**EMAN Zoning Committee**

**Variance Request Review: Application Number: ZP-2021-003849  
244 E Springer St.**

**Existing**  
**1 Vacant Lot**  
**Approx. 54.2' by 60'**  
**16-ft wide, No Outlet Street**

**Proposed**  
**2 Semi-Detached Single**  
**Family,**  
**3-story Homes**

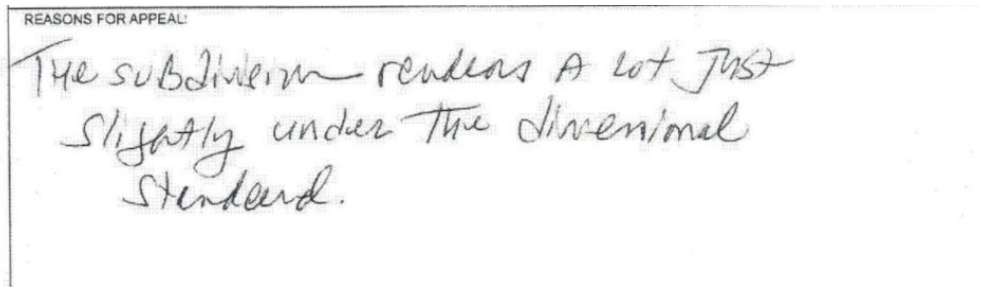
**L&I Notice of Refusal**, L&I issued a notice of refusal for the proposed 244 E Springer St. zoning permit application by Vern Anastasio DBA: Law (Applicant) on 8/18/21. The image below shows L&I’s zoning non-compliance for minimum lot size:

# 244 E. SPRINGER ST GARAGE/DRIVEWAY STUDY

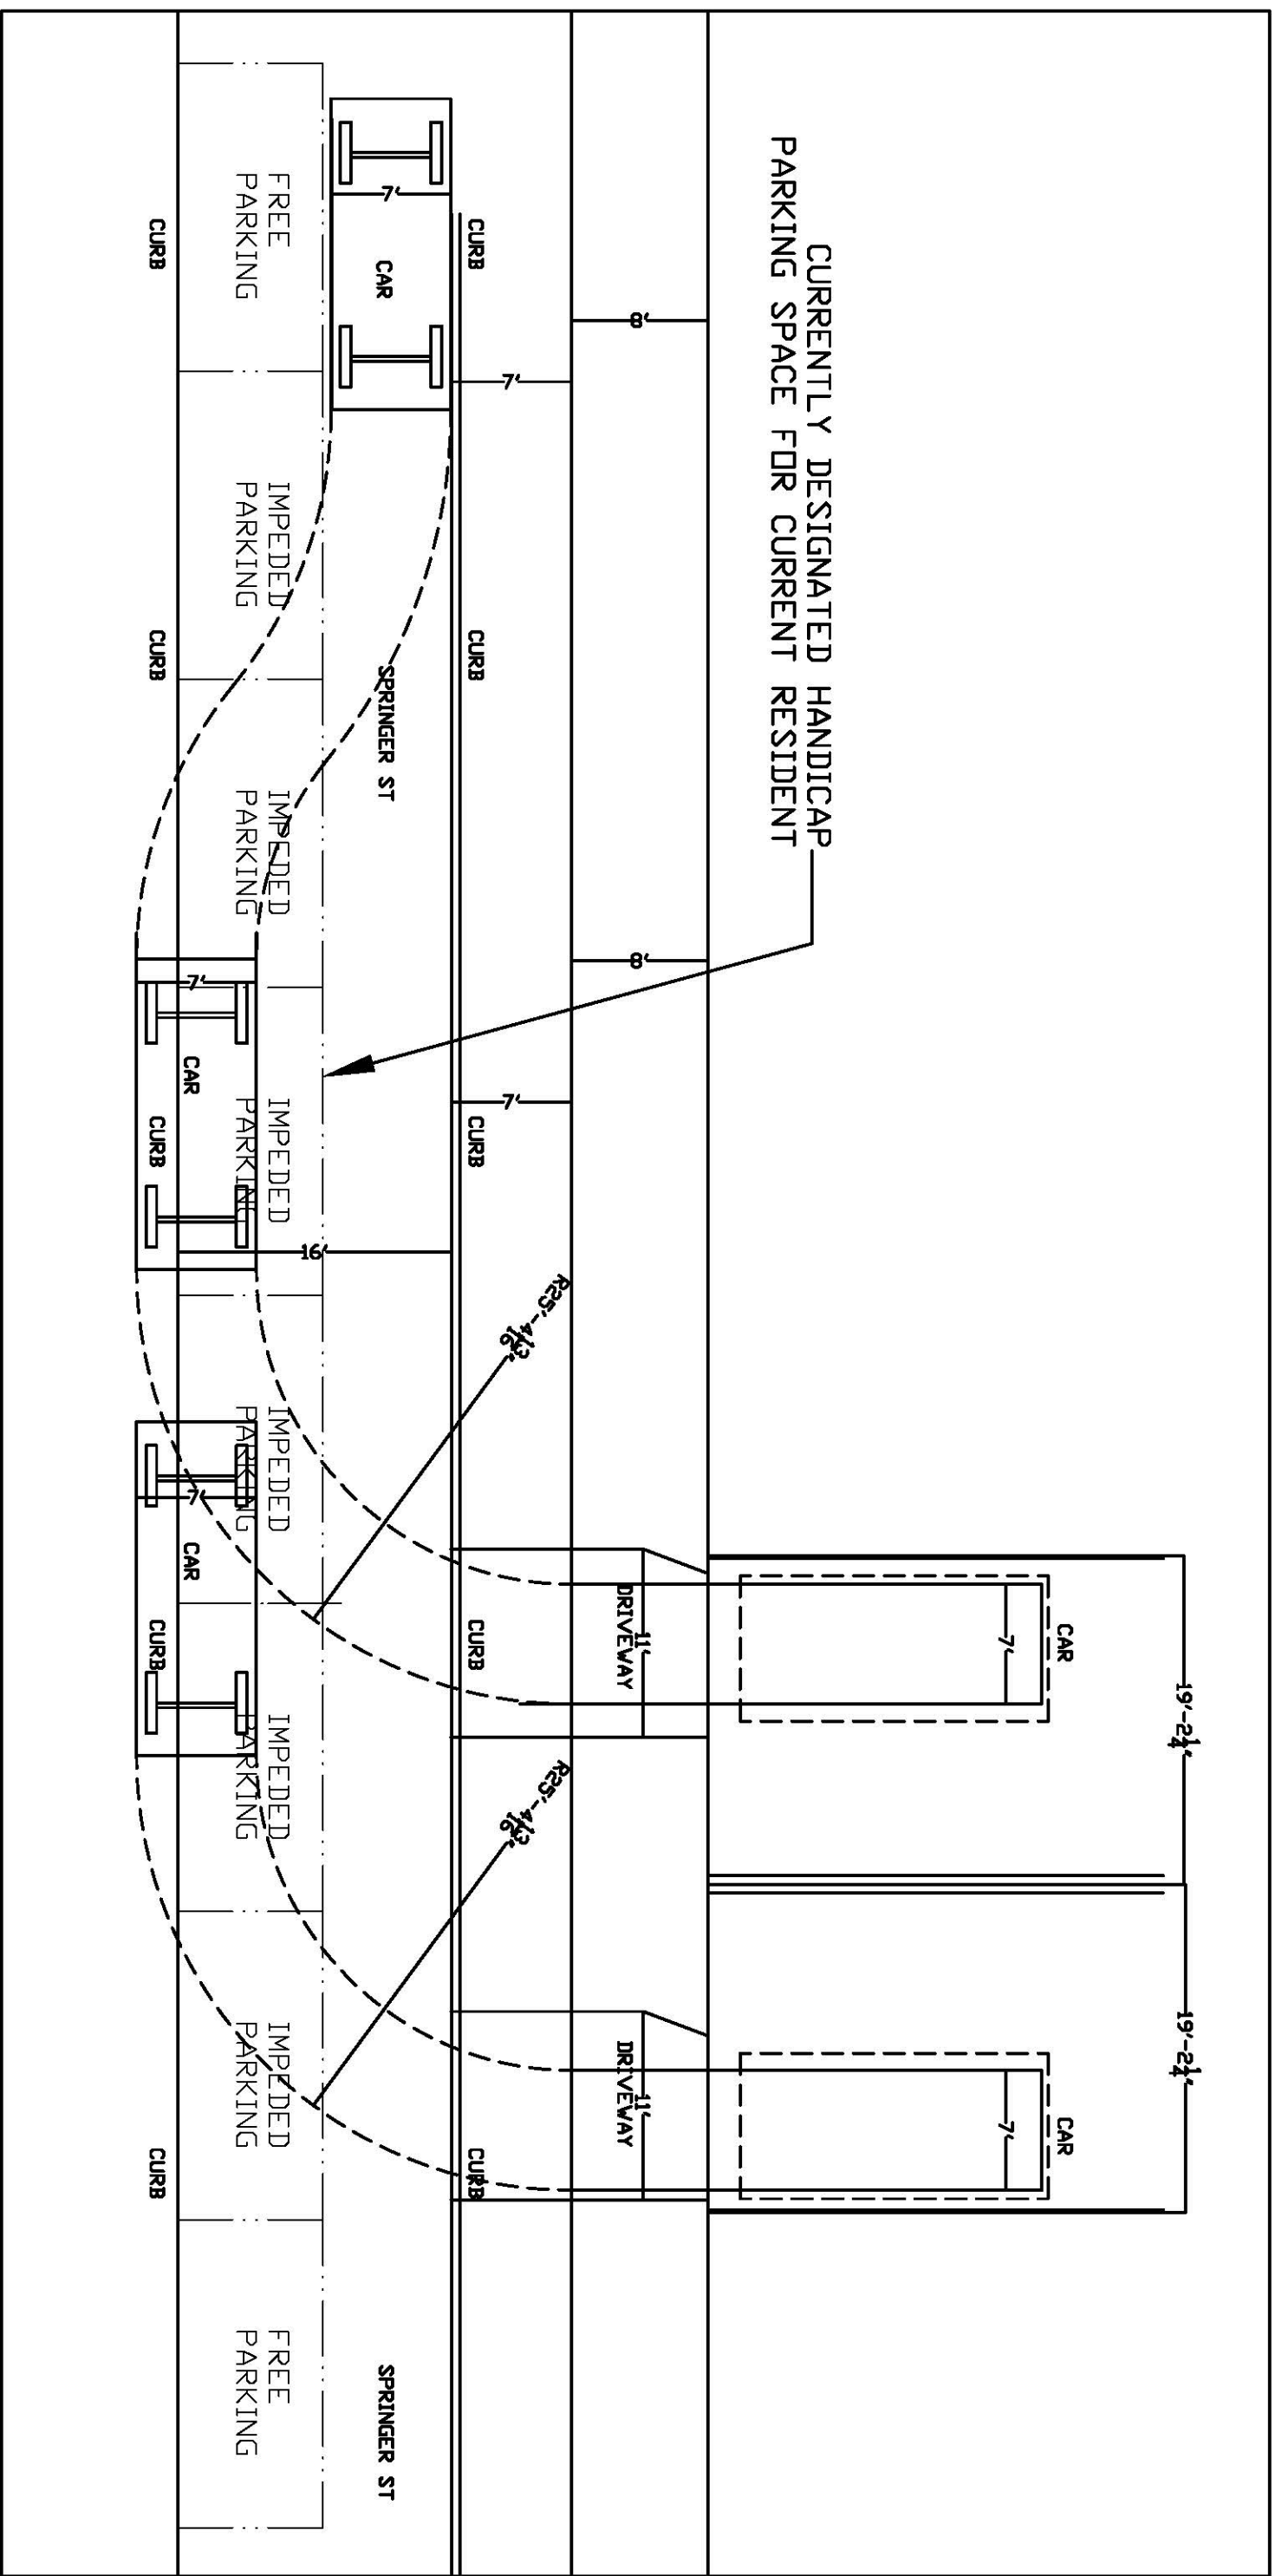
The Zoning Committee has prepared a Garage/Driveway Study to assess feasibility of driveways and garage parking on E Springer St’s 16ft wide pavement. Exhibit 1 shows a drawing that shows several issues with the Applicant’s proposed garage driveways using the 25.4ft overhang radius shown in the Applicant’s Diagram 8.

1. Proposed home residents would need to encroach on the odd-side sidewalk to be able to make the turn into the proposed garages.
2. Six odd-side of the street parking spaces would need to be eliminated to provide open turning access space for the 2 proposed garages.
3. The currently designated handicap parking permit across from the proposed new homes would need to be relocated to provide turning access for the garages.
4. Residents of the proposed homes would need to either back in or back out of E Springer St to enter and leave their garages or additional odd-side parking would have to be eliminated to enable the residents to adjust their car direction.

**Zoning Committee Comment No. 6:**

The Zoning Committee is concerned about the feasibility of the proposed turning paths for the proposed garages at 244 E Springer St. Please provide information on the impact of the proposed entry and exit turning radii of vehicles to the proposed garages on odd-side street parking and relocation of the current permitted handicap parking permit.
